Consumers
Power
Company

August 26, 1982

MIDLAND NUCLEAR COGENERATION PLANT
MIDLAND DOCKET NOS 50-329, 50-330
REACTOR VESSEL HEAD VENT
FILE: 0505.16 SERIAL: 18434

Figure 1

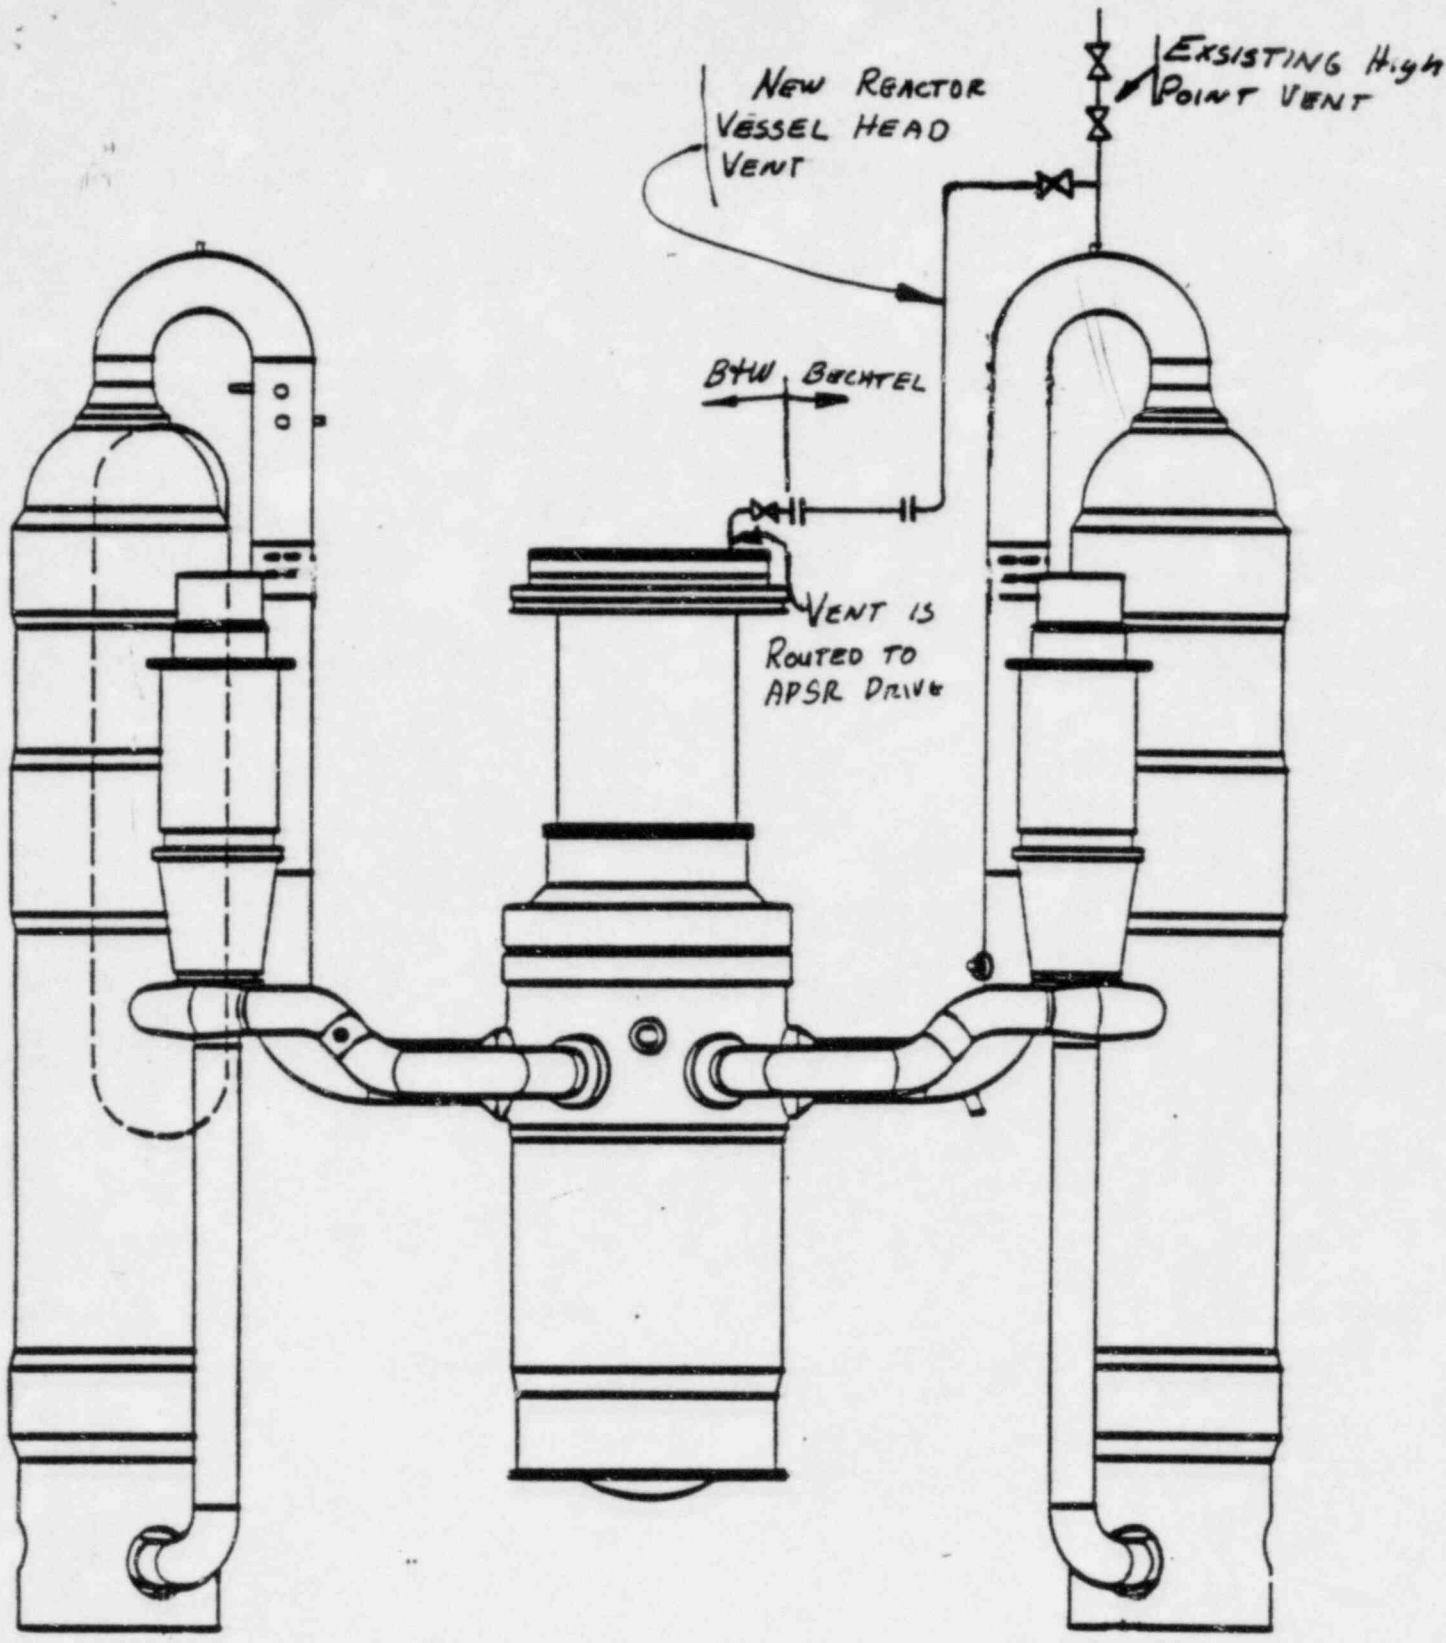
In response to the Staff's position stated in the SER, sections 4.4.4 and 5.4.7 Consumers Power Company proposes to provide a vent connection between the top of the reactor vessel head, and the top of one of the hot legs as conceptually shown in the attached sketch, Figure 1. The line would provide for venting and purging of the reactor head volume. The vent on the hot leg would allow venting from the system of any non-condensibles. By providing the proposed connection, the hot leg level monitoring system would also provide level monitoring for the reactor vessel to the bottom of the hot leg. CPCo believes that this design, because of its inherent simplicity has sufficient merit to warrant continuation with detailed design and analysis. Our projected schedule would ensure installation by the first scheduled refueling outage, however we will endeavor to complete design and installation prior to fuel load, if practicable.
